RAI: Volume 3, Chapter 2.2.1.2.2, Number 2:

Response Tracking Number: 00049-00-00

RAI: 3.2.2.1.2.2-002

Figure 1. Alternate Event Tree for Evaluating Mishandling of the Waste Package Outer Corrosion Barrier

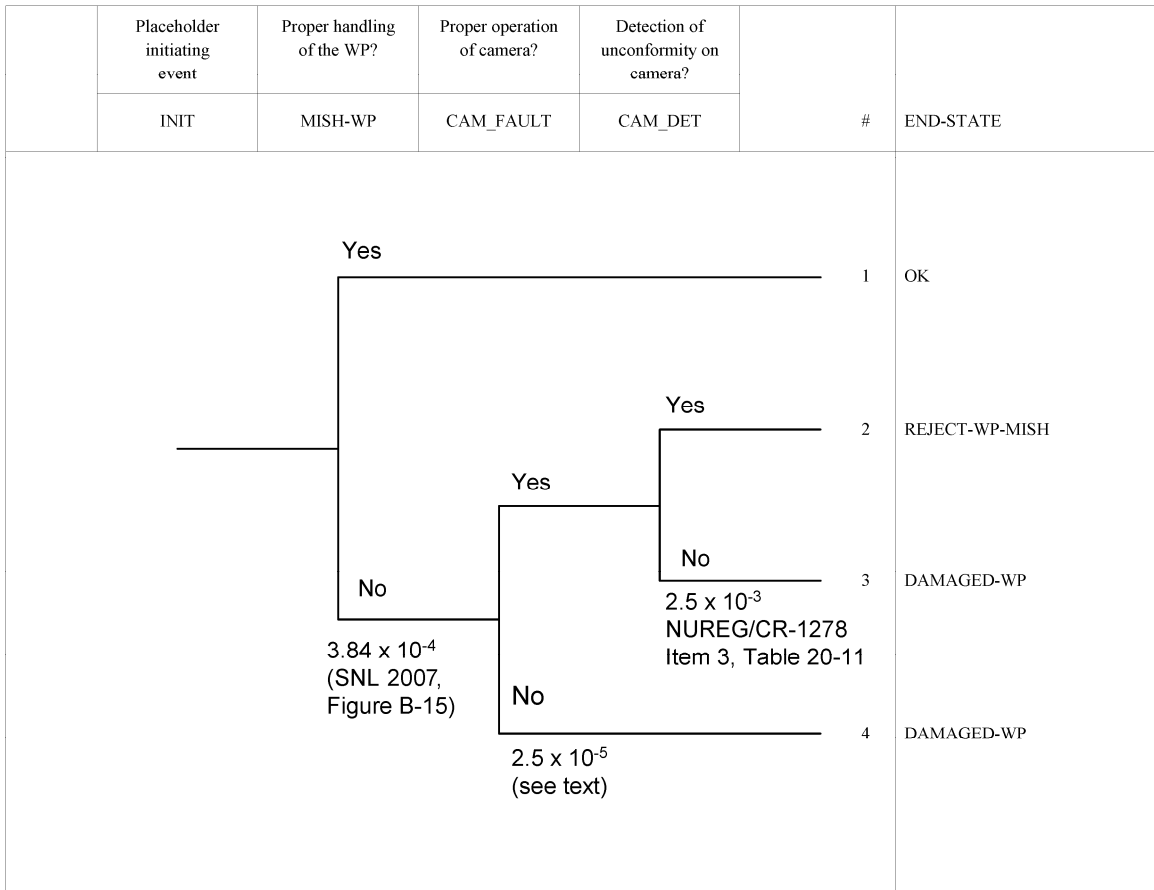
Provide additional justification for the probability value for a camera not detecting damage to an emplaced waste package.

Basis: DOE proposes to use a camera to remotely detect damage to the waste package surface that may occur during emplacement (SNL, 2007a, as referenced in SAR, Section 2.3.6.6.3.2.6). For the probability that the damage is not detected, DOE gives a mean value of 2.50×10^{-3} and error factor of 3. This value is defined as a human error event with a value taken from Swain and Guttman (1983): the “error of commission in check-reading analog meter.” DOE has not sufficiently justified how the error probability for “check-reading analog meter” appropriately estimates the error in using a camera to examine the waste package surface for damage. In addition, the error estimate has not considered the potential for mechanical failure of the camera or such factors as a partially degraded visual image. The error estimate and associated uncertainty also does not account for the potential inability of the camera to visualize the entire waste package surface, including the part resting on the pallet.

Figure B-14 in *Analysis of Mechanisms for Early Waste Package/Drip Shield Failure* (SNL 2007) presents the event tree used to compute the contribution to the probability of waste package early failure from the occurrence of damage during waste package emplacement, and the failure to detect such damage during inspections. This event tree does not include an event sequence that accounts for the possibility that faults in the camera may result in undetected flaws in the waste package outer corrosion barrier. Figure 1 below illustrates an alternate event tree that includes an event sequence accounting for camera faults.

Evaluation of the event tree shown in Figure 1 yields a mean probability of occurrence of damage to the waste package outer corrosion barrier from mishandling, the failure to detect such damage during inspections, of 9.70×10^{-7} , equivalent to the mean probability of 9.71×10^{-7} estimated by the Monte Carlo analysis performed with SAPHIRE (Table 1 in DOE’s response to RAI 3.2.2.1.2.2-002) that results from the event tree presented in Figure B-14 of *Analysis of Mechanisms for Early Waste Package/Drip Shield Failure* (SNL 2007). Waste package mishandling is one of six possible event sequences that contribute to the overall probability of waste package early failure. If the increase in the probability of damage from waste package mishandling due to including the possibility for faults in the camera was included, the sum of the mean probabilities over all event sequences would not change from 1.13×10^{-4} (SAR Section 2.3.6.6.3.2.7) Thus, inclusion of the possibility of camera faults has a negligible effect on the analysis of early failures reported in *Analysis of Mechanisms for Early Waste Package/Drip Shield Failure* (SNL 2007).
